Subject: RE: Contract for your Review and Signature- Highlands Estate

Subject: RE: Planning Comments on 10/17/17 submittal

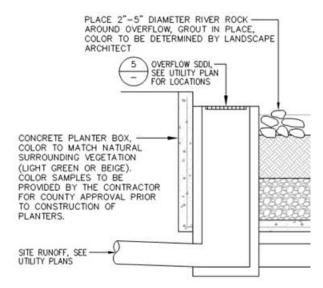
Comment #1: Planters are located in the yards, so planters should not match the buildings but the surrounding vegetation.

Response: Please clarify comment. Notes are already on the plans for planter color to match natural surrounding vegetation (light green or beige) and color samples to be provided for County approval prior to construction of planters as shown below.

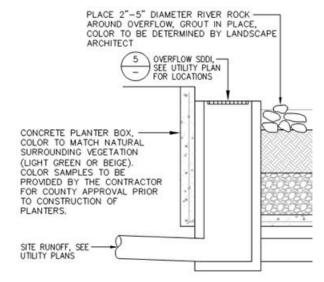
Comment #1: Planters are located in the yards, so planters should not match the buildings but the surrounding vegetation.

Response: Please clarify comment. Notes are already on the plans for planter color to match natural surrounding vegetation (light green or beige) and color samples to be provided for County approval prior to construction of planters as shown below.

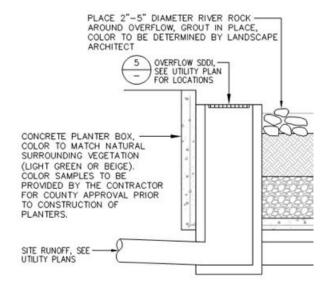
Comment #1: Planters are located in the yards, so planters should not match the buildings but the surrounding vegetation.

Response: Please clarify comment. Notes are already on the plans for planter color to match natural surrounding vegetation (light green or beige) and color samples to be provided for County approval prior to construction of planters as shown below.

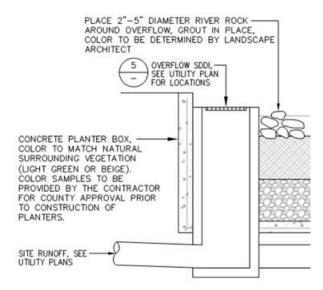
Comment #1: Planters are located in the yards, so planters should not match the buildings but the surrounding vegetation.

Response: Please clarify comment. Notes are already on the plans for planter color to match natural surrounding vegetation (light green or beige) and color samples to be provided for County approval prior to construction of planters as shown below.
